Access Compliance Report

Public Rights-of-Way (Curb Ramps)

Intersection ID: 27422	Main Street: BALLANTYNE_COMMONS_PY	Cross Street: STONEBRIAR_DR	Location: NW
ADA ID: D74047CB2644	Ramp Type: Perp	Initial Pass/Fail: Fail	Overall Compliance: No
Codes/Mitigation Info/Possible Solution		Field Measurements/Component Compliance

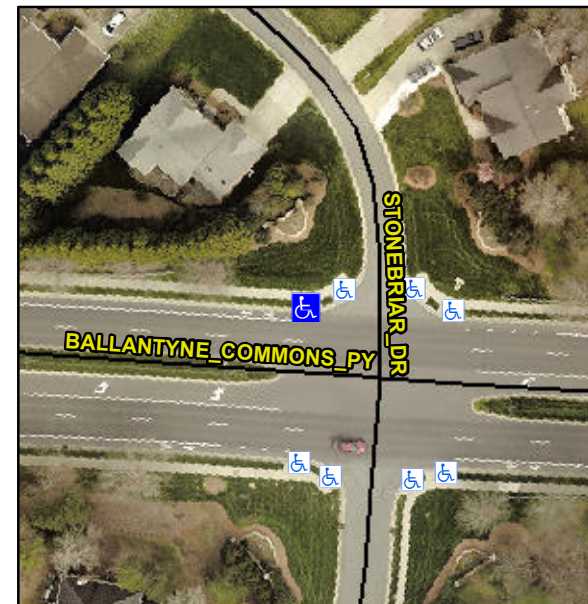
Not Found, R304.5.1, R304.2.2, R304.5.3

Compliance	Description	Data	Compliance	Description	Data
N/A	Ramp Length (in)	106.5	No	Ramp Slope (%)	8.9
No	Ramp Width (in)	37.0	No	Ramp XSlope (%)	7.1
N/A	Flare Type LT	N/A	N/A	Flare Type RT	N/A
N/A	Flare Slope LT (%)	N/A	N/A	Flare Slope RT (%)	N/A
N/A	Flare Traversable LT?	N/A	N/A	Flare Traversable RT?	N/A
N/A	Landing Length (in)	N/A	N/A	DWS Provided?	N/A
N/A	Landing Width (in)	N/A	N/A	DWS Contrast?	N/A
N/A	Landing Slope (%)	N/A	N/A	DWS Length (in)	N/A
N/A	Landing X Slope (%)	N/A	N/A	DWS Full Width?	N/A
N/A	Landing Curb? (Y/N)	N/A	N/A	DWS Offset (in)	N/A
N/A	Shared Landing?	N/A			
N/A	Gutter Ponding?	N/A	N/A	Gutter Slope (%)	N/A
N/A	Gutter Lip Ht (in)	N/A	N/A	Gutter X Slope (%)	N/A
N/A	Painted X Walk1?	No	N/A	Painted X Walk2?	N/A
	X Walk 1 Direction	To S		X Walk 2 Direction	N/A
N/A	X Walk 1 Width (in)	N/A	N/A	X Walk 2 Width (in)	N/A
	X Walk 1 Slope (%)	2.8		X Walk 2 Slope (%)	N/A
	X Walk 1 X Slope (%)	4.0		X Walk 2 X Slope (%)	N/A

Remove & Replace Entire Ramp.
